NASA Engineering and Safety Center Technical Position Paper	Document #: RP-06-53	Version: 1.0
Title: External Tank (ET) Bipod Fitting Bolted Attachment Locking Insert Performance			Page #: 1 of 18

External Tank Bipod Fitting Bolted Attachment Locking Insert Performance

June 22, 2006

Figure 3.0-1. Insert and Bolt Used in the Design
[ref. Wingate, ET Bipod Fitting Bolted Joint Attachment Design and Locking Insert Performance presentation, June 13, 2006]

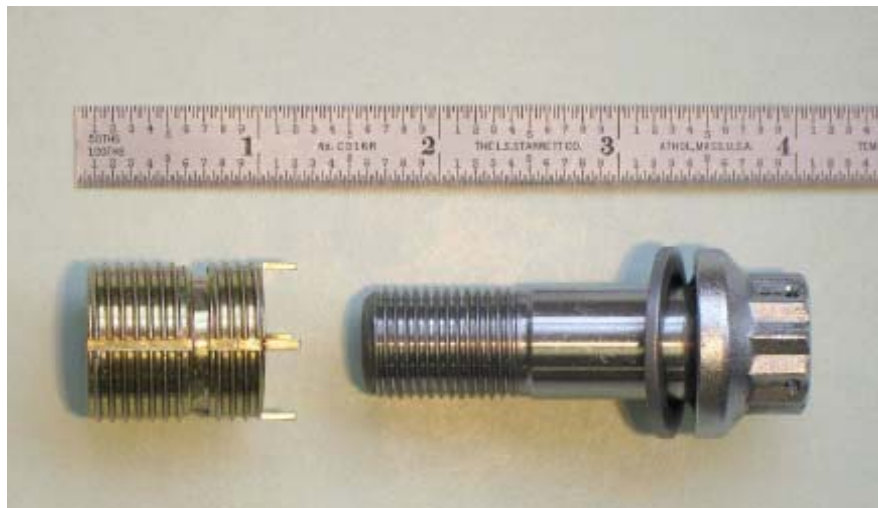
Following STS-107, the External Tank (ET) Project implemented corrective actions and configuration changes at the ET bipod fitting. Among the corrective actions, the existing bolt lock wire which provided resistance to potential bolt rotation was removed. The lock wire removal was because of concerns with creating voids during foam application and potential for lock wire to become debris. The bolts had been previously lubricated to facilitate assembly but, because of elimination of the lock wire, the ET Project wanted to enable the locking feature of the insert. Thus, the lubrication was removed from bolt threads and instead applied to the washer under the bolt head. Lubrication is necessary to maximize joint pre-load while remaining within the bolt torque specification. The locking feature is implemented by thread crimping in at four places in the insert. As the bolt is torqued into the insert the bolt threads its way past the crimped parts of the insert. This provides the locking of the bolt, as torque is required to loosen the joint after clamping. Refer to Figures 3.0-1 and 3.0-2.
